# Access Compliance Report

## Public Rights-of-Way

| Intersection ID: 2675 | Main Street: HEATHCREST_CT | Cross Street: MCCHESENEY_DR | Location:              | S                    |
| ADA ID: DC3E42B452F7  | Ramp Type: Perp            | Initial Pass/Fail: Fail     | Overall Compliance: No | Severity Score: 12.5 |

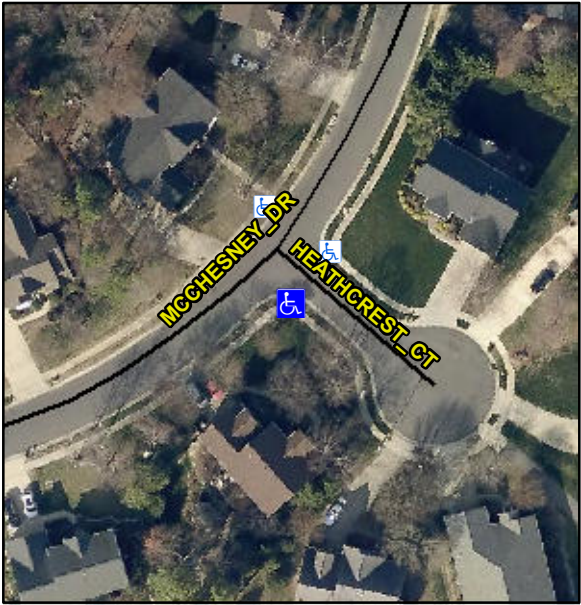
| Codes/Mitigation Info/Possible Solution   |  |            | Field Measurements/Component Compliance |                          |             |
|---|--|------------|---|--------------------------|-------------|
|   | <b>Remove &amp; Replace Entire Ramp.</b> |            | <b>Yes</b>                              | Ramp Length (in)         | 52.0        |
|   |  |            | <b>No</b>                               | Ramp Width (in)          | 48.0        |
| <p>Surveyor Notes:</p> <p><b>N/A</b></p> <p>PROW/ADA:</p> <p><b>Not Found, R304.5.3</b></p> |  |            | <b>N/A</b>                              | Flare Type RT            | N/A         |
